Adding wideband MMF to 400GBASE-SR16

802.3bs Interim, September 2016,
Fort Worth, Texas

Changes to 802.3bs Draft 2: Amendment to Clause 1.3

Table 123–7—Optical fiber and cable characteristics

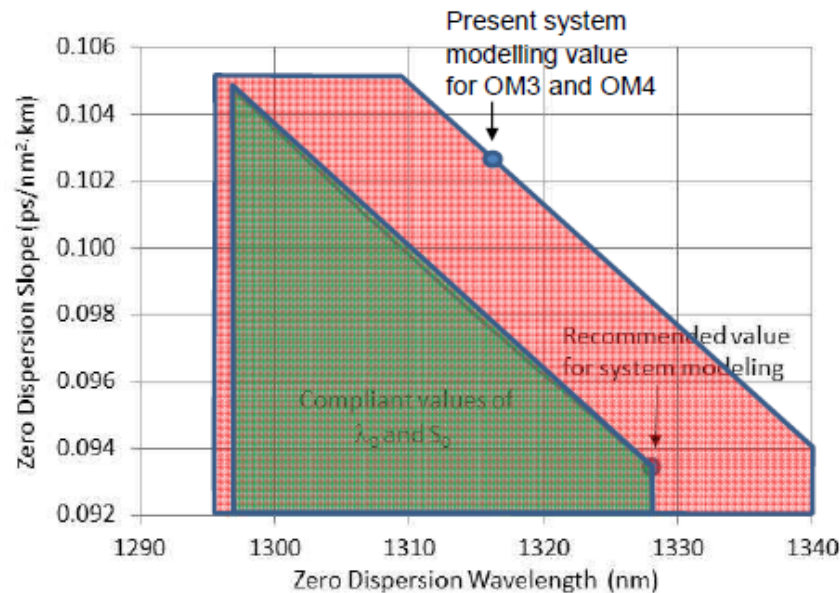
Changes to 802.3bs Draft 2: Clause 123.11

- In Table 123–7, add spec column for wideband MMF cabling characteristics
 - Head of column title 'Wideband MMF^c'
 - Footnote 'c' becomes 'TIA-492AAAE'
 - Add footnote 'd' 'When measured with the launch conditions specified in Tale 95-6'
 - 'Nominal core diameter' 50 μm
 - 'Nominal fiber specification wavelength' 850 nm
 - 'Effective modal bandwidth' 4700 MHz.km
 - 'Cabled optical attenuation' 3.5 dB/km
 - 'Zero dispersion wavelength (λ_0)' $1297 \leq \lambda_0 \leq 1328$ nm
 - 'Chromatic dispersion slope (max) (S_0)' $\leq 4(-103)/(840(1-(\lambda_0/840)^4))$ ps/nm²km
